PERCEPTION PLANNING

BUILDING CODE OF AUSTRALIA REVIEW

**360 WALLAROBBA BROOKFIELD RD, BROOKFIELD
NSW 2420**

STATUS	For design review
REPORT	DA-Level
STRUCTURE(S)	Proposed Dwelling House
TITLE	Lot 18, DP1279754
PREPARED	CA
REVIEWED	MB
CLIENT	Stephen Bartrop

Markup - Indicative Smoke Alarm Location

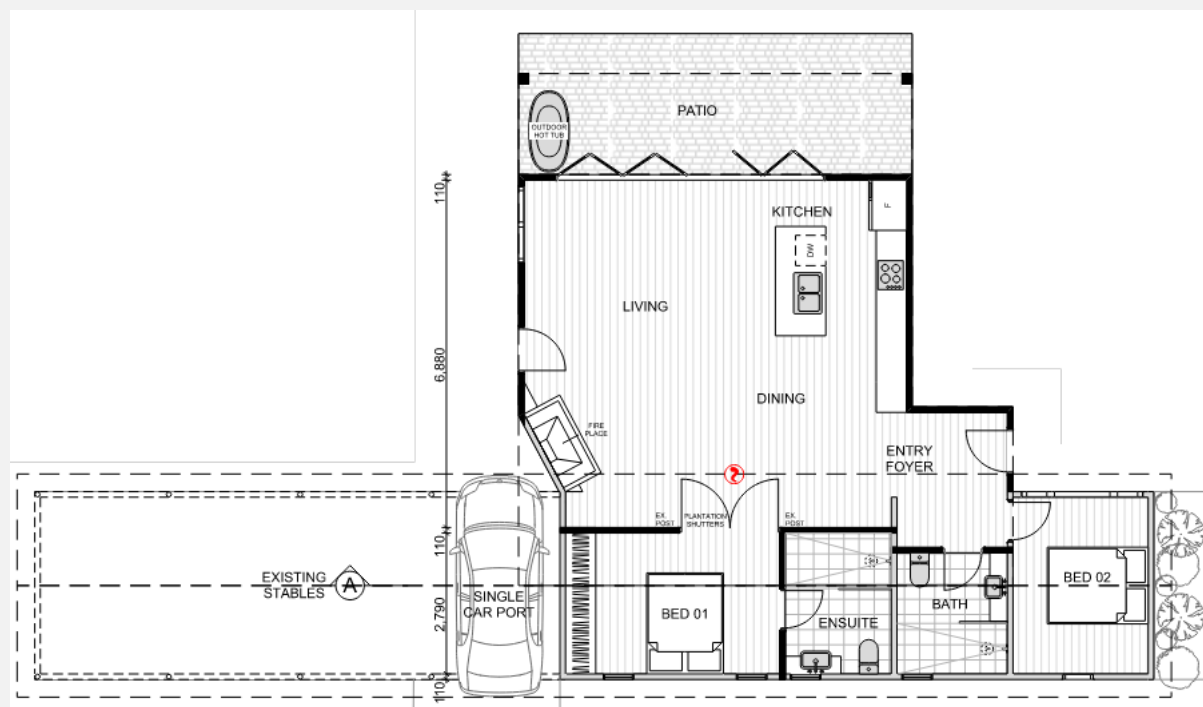
Smoke alarms in Class 1a buildings must be located in any storey containing bedrooms, positioned in an area between the bedrooms and the remainder of the building. Additionally, in buildings with multiple storeys, smoke alarms must be installed on each other storey. A markup showing an example of a suitable location for the required smoke alarm is provided below:

Where smoke alarms are installed on a ceiling, it must be a minimum of 300 mm away from the corner junction where the wall meets the ceiling, and between 500 mm and 1500 mm away from the high point / apex of a sloped/raked ceiling.
